PROJECT: LAKELAND FARMS
TOWNHOUSE COMMUNITY
84 CLEVELAND STREET
NORFOLK, MA 02056

UTILITY PLAN

DRAWING NO.
	C-4.0
	PLAN NO. L-4819

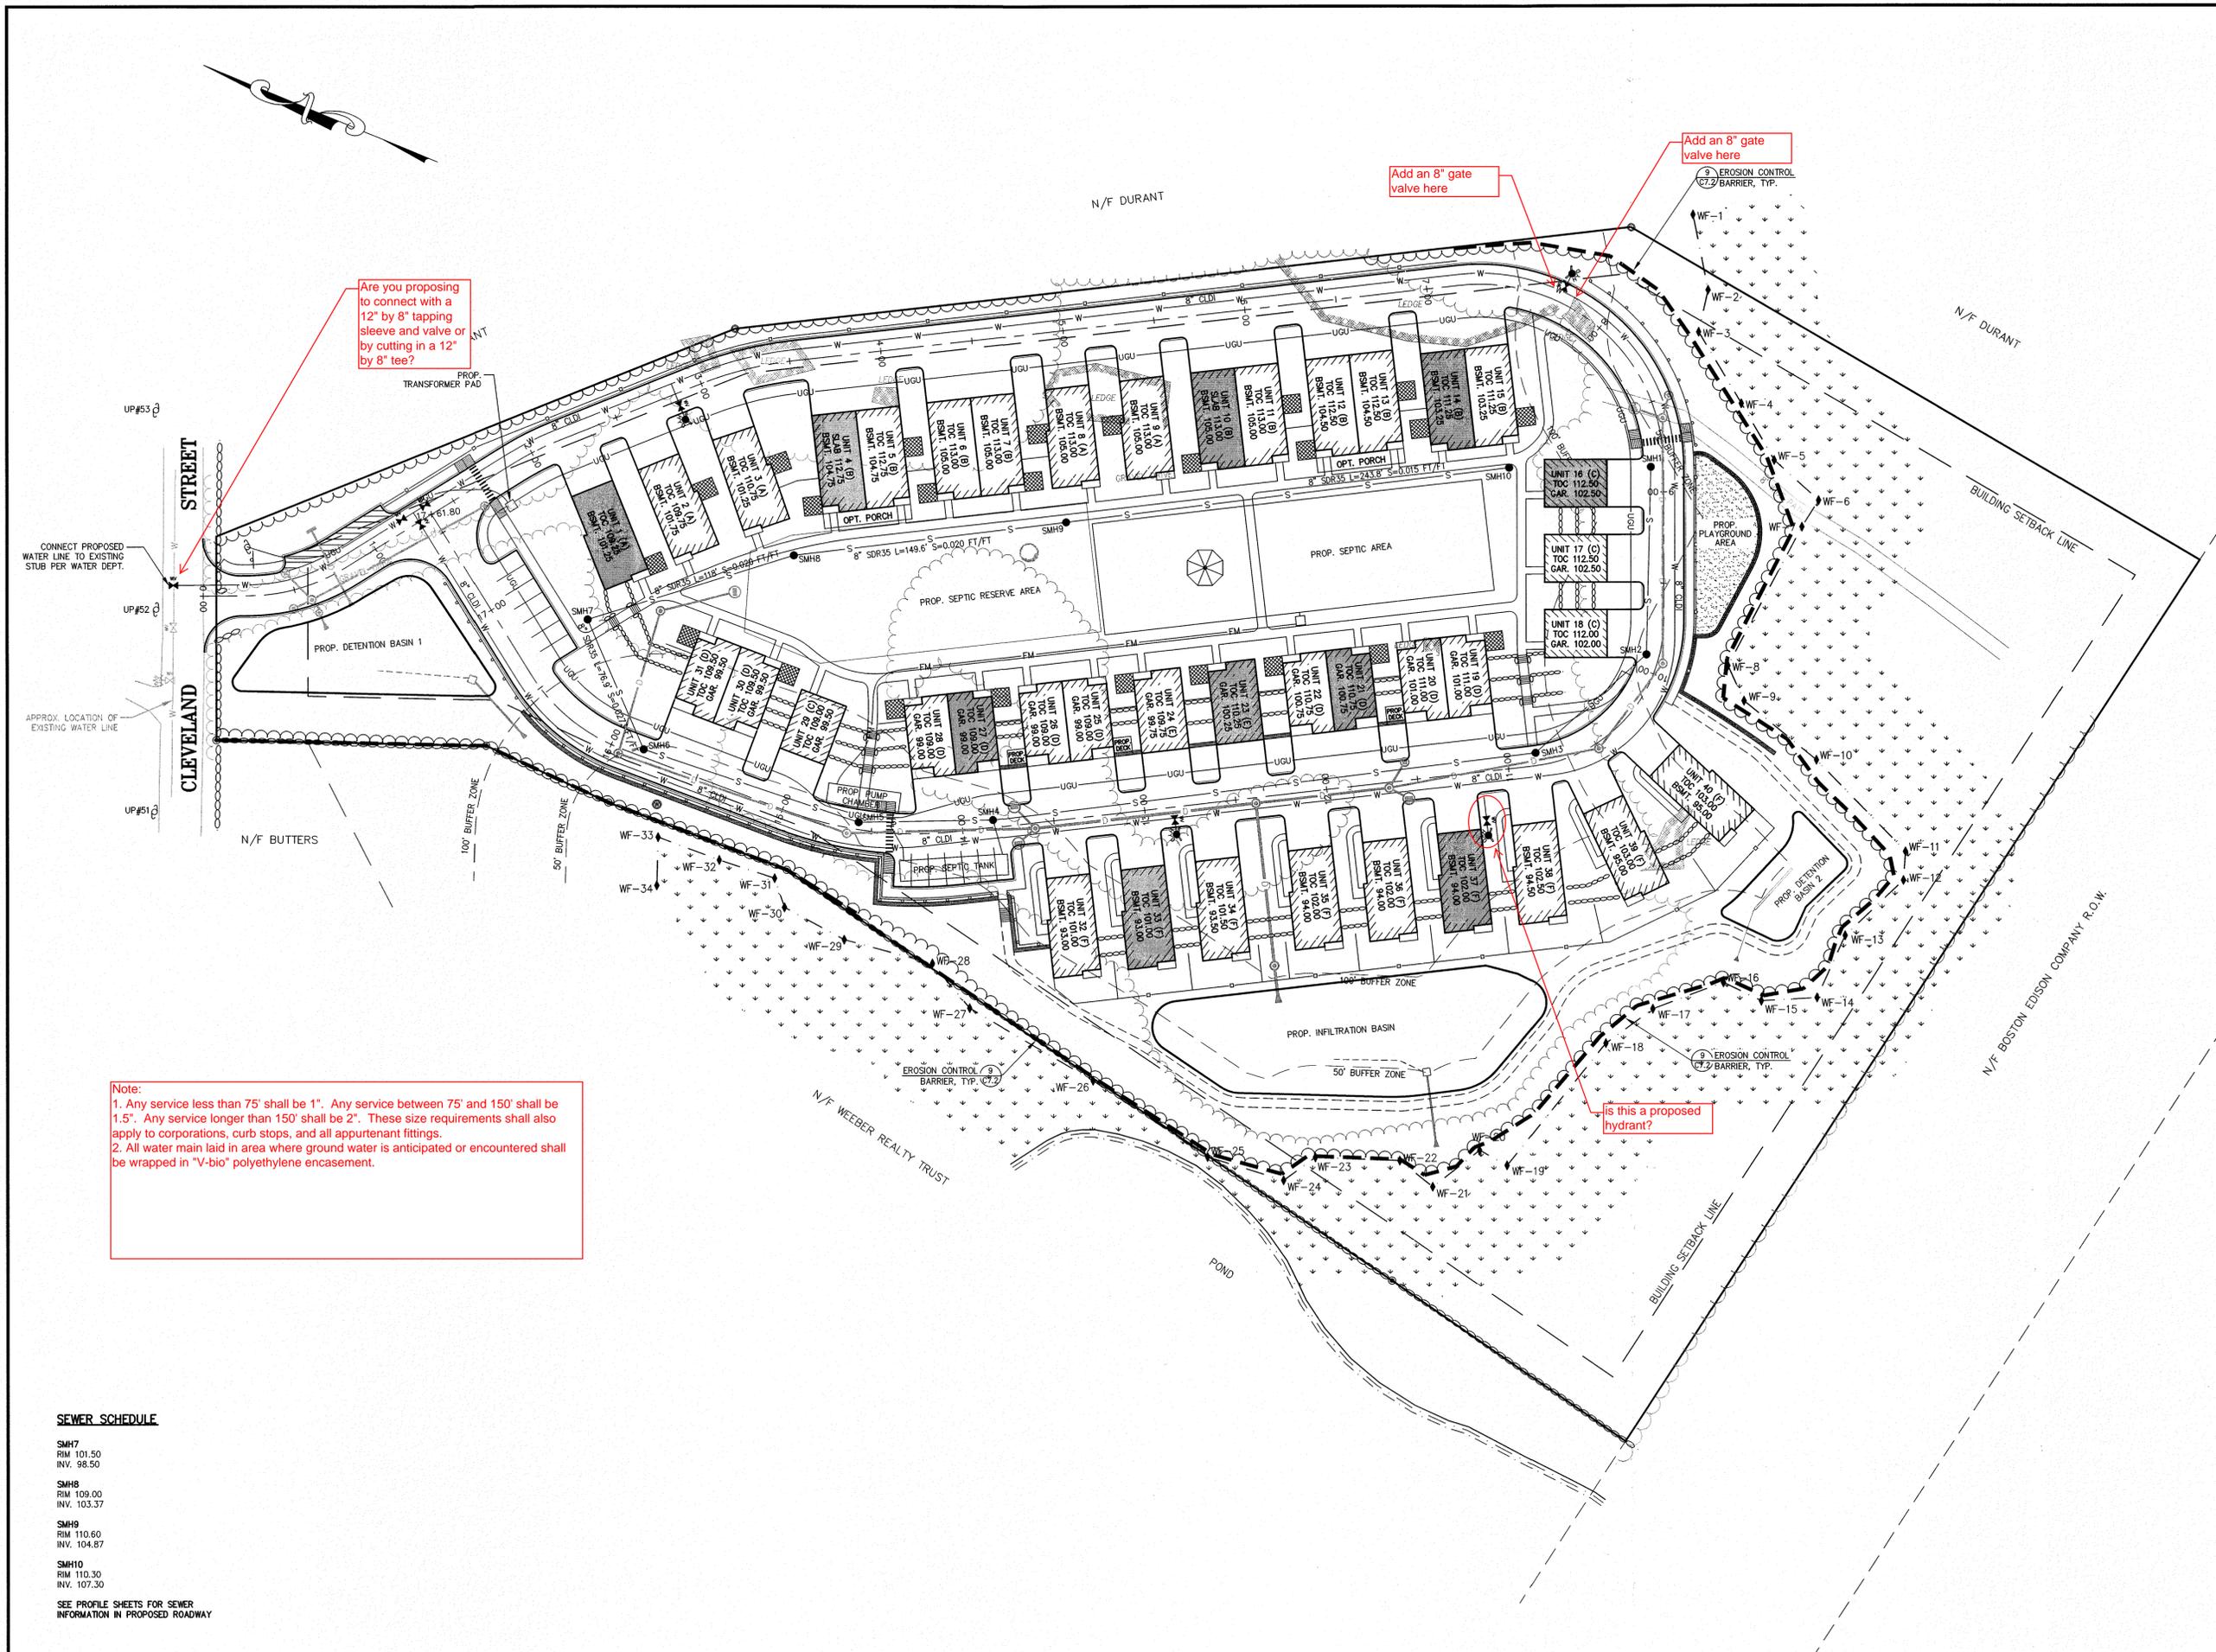
Are you proposing to connect with a 12" by 8" tapping sleeve and valve or by cutting in a 12" by 8" tee?

Add an 8" gate valve here

Add an 8" gate valve here

is this a proposed hydrant?

Note:
1. Any service less than 75' shall be 1". Any service between 75' and 150' shall be 1.5". Any service longer than 150' shall be 2". These size requirements shall also apply to corporations, curb stops, and all appurtenant fittings.
2. All water main laid in area where ground water is anticipated or encountered shall be wrapped in "V-bio" polyethylene encasement.

1 TYPICAL WATER SUPPLY DETAILS
SCALE: N.T.S.

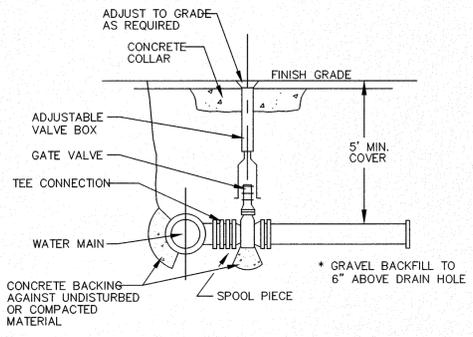
service
with pack joint

6 TYPICAL FIRE HYDRANT CONNECTION DETAIL
SCALE: N.T.S.

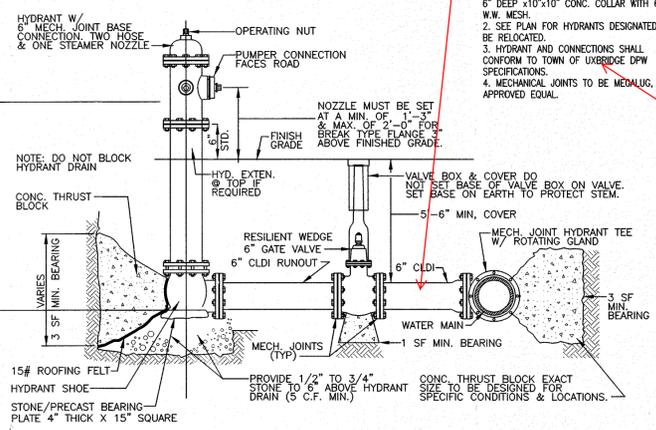
Eliminate spool length and bolt valve directly to the anchor tee unless field conditions necessitate otherwise.
